Bayside Planning Panel

Item No	6.2
Application Type	Development Application
Application Number	DA-2017/284
Lodgement Date	2 March 2017
Property	1 Caledonian Street, Bexley
Owner	Nova Investment Trading Pty Ltd
Applicant	The Site Foreman (NSW) Pty Ltd
Proposal	Construction of a two(2) storey multi dwelling housing development containing seven (7) townhouses, basement car parking and demolition of existing structures
No. of Submissions	Seventeen (17) – Original notification Two (2) – Second notification
Cost of Development	\$2,952,383.00
Report by	Creative Planning Solutions Pty Ltd

Supplementary Planning Report

Application Number:	DA-2017/284
Date of Receipt:	2 March 2017
Property:	1 Caledonian Street, Bexley NSW 2207
Owner:	Nova Investment Trading Pty Ltd
Applicant:	The Site Foreman (NSW) Pty Ltd
Proposal:	Construction of a two storey multi dwelling housing development containing seven townhouses, basement car parking and demolition of existing structures.
Recommendation:	Approval, subject to conditions
Submissions:	First Round: Seventeen (17) submissions – all objecting to the proposal. Second Round: Two (2) submissions – both objecting to the proposal.
Author:	Creative Plannin

Figure 15. Section drawing indicating view lines from the ground floor of Unit 7 to adjoining POS
(Source: The Site Foreman, 2017; Marked by CPS, 2017)

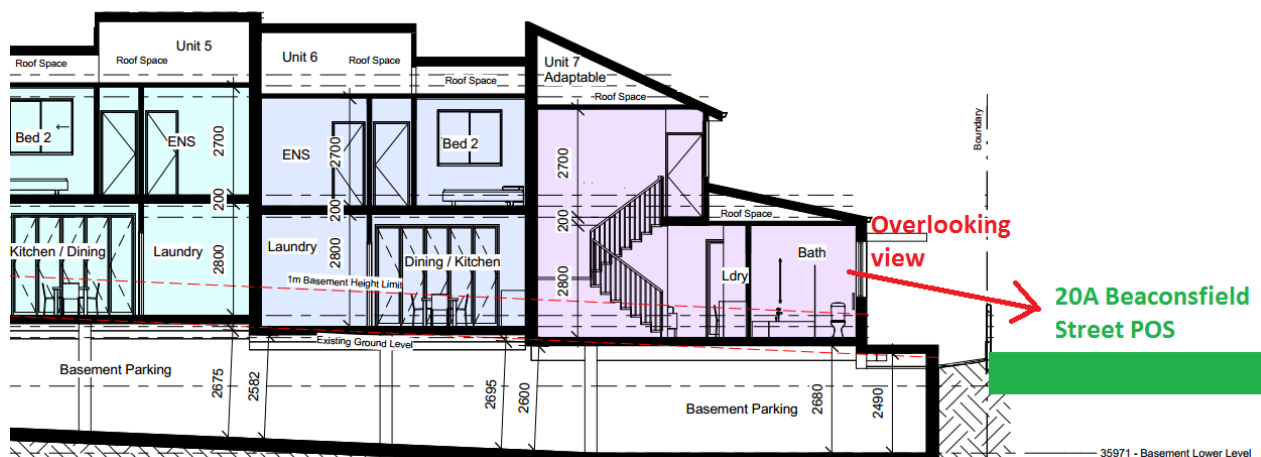
Of particular privacy concern is the views from the main open plan living, dining and kitchen area of Unit 7 which is considered to be the highest utilised and most active area within the dwelling. Furthermore, the views from this area to the adjoining private open space will be expansive as full width and height glazed sliding doors are proposed to the rear. Given these circumstances, it is recommended the rear glazed sliding doors are replaced with a singular door that is obscure glazed or solid to a height of 1.7m above finished floor level. The wording of this condition is specified below. This singular door will ensure that when opened that only narrow restricted views will be possible and will still allow for direct access to the rear deck. It is noted that this requirement will not significantly reduce the amenity Unit 7 as the living room is oriented to the north-eastern side rather than the rear, with glazed sliding doors providing access to the primary private open space area within that side. The rear doors to be replaced are south facing, receive no direct sunlight, and only provide access to a narrow ancillary portion of the deck.

Prior to the issue of a Construction Certificate, the ground-floor sliding doors to the south-eastern elevation of Unit 7 are to be replaced with a singular door, no greater in width than that is required to meet BCA and accessibility standards, that is obscure glazed or solid to a height of 1.7m above finished floor level to prevent overlooking of adjoining properties.

Prior to the issue of a Construction Certificate, the ground-floor windows to the bathroom and study on the south-eastern elevation of Unit 7 are to be obscure glazed and non-openable to a height of 1.7m above finished floor level to prevent overlooking of adjoining properties.

DRAWN BY	FS
SCALE	1 : 200
JOB NO	2509
DRAWING NO	DA03 J

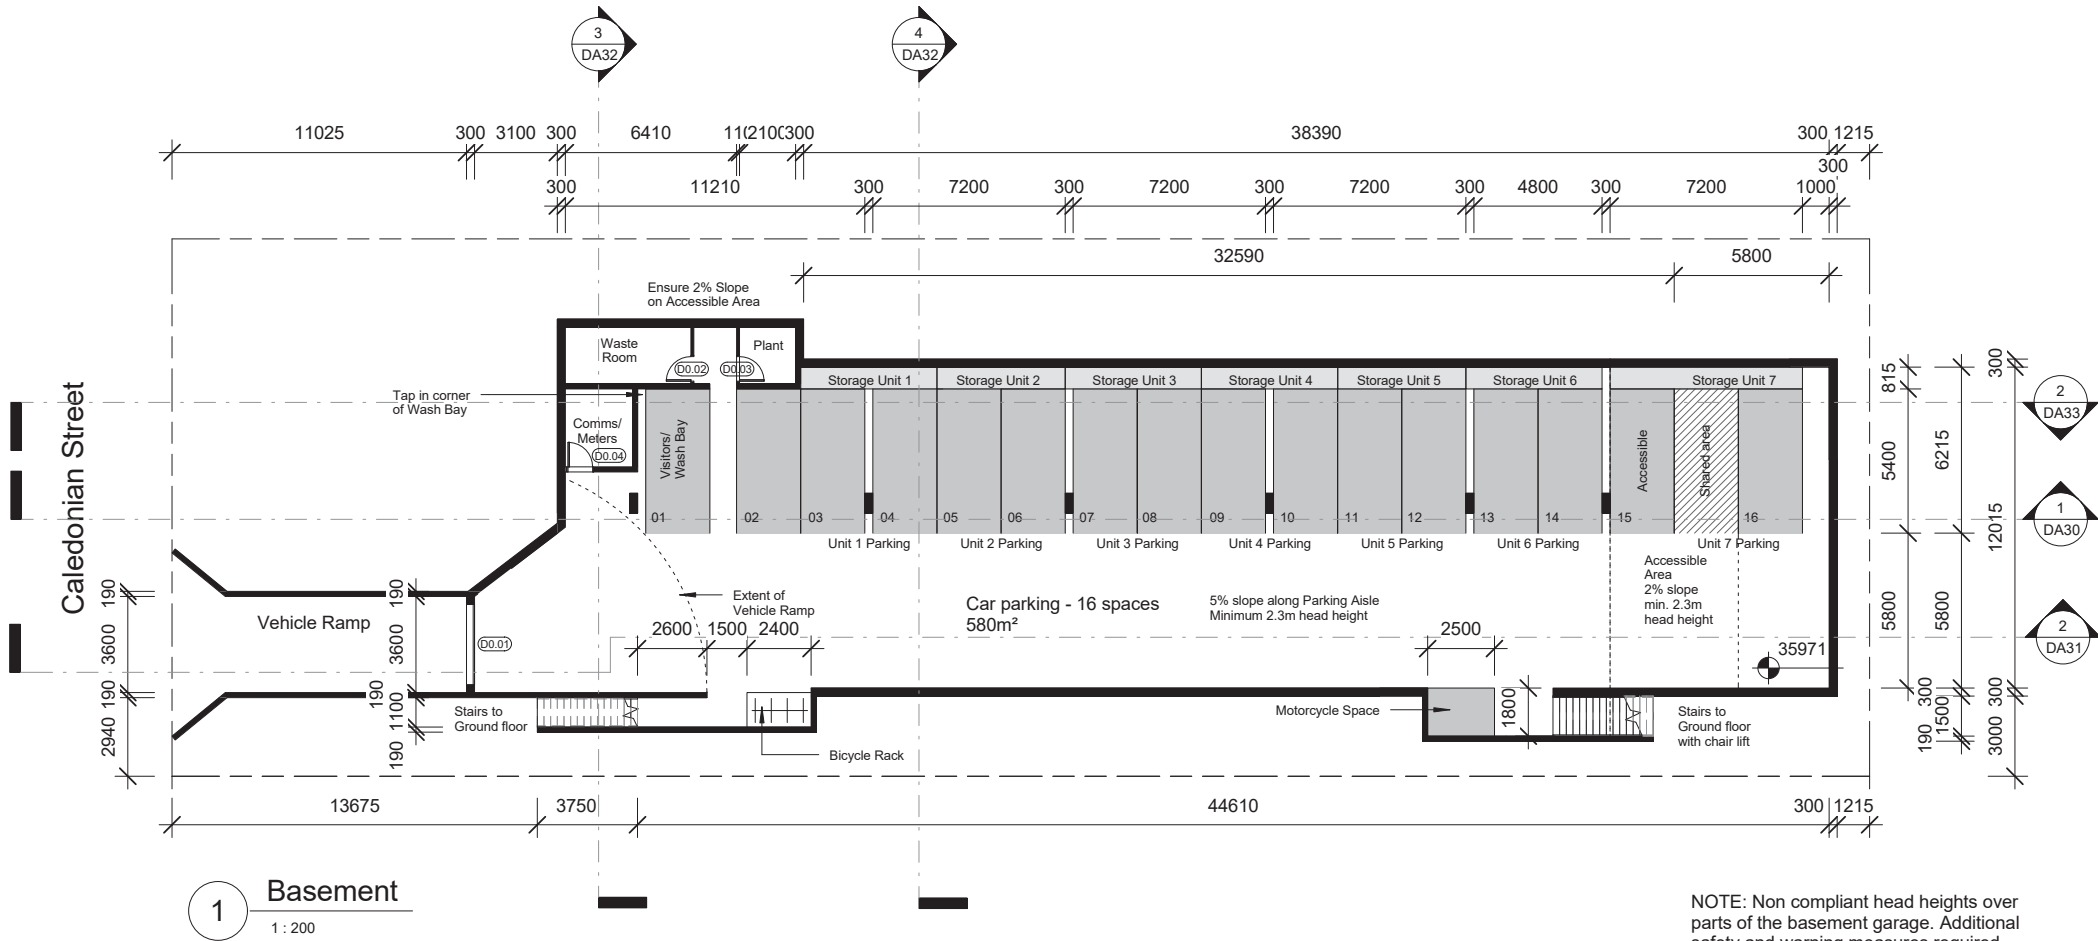
NOTE: Non compliant head heights over parts of the basement garage. Additional safety and warning measures required. Refer to traffic engineering report.
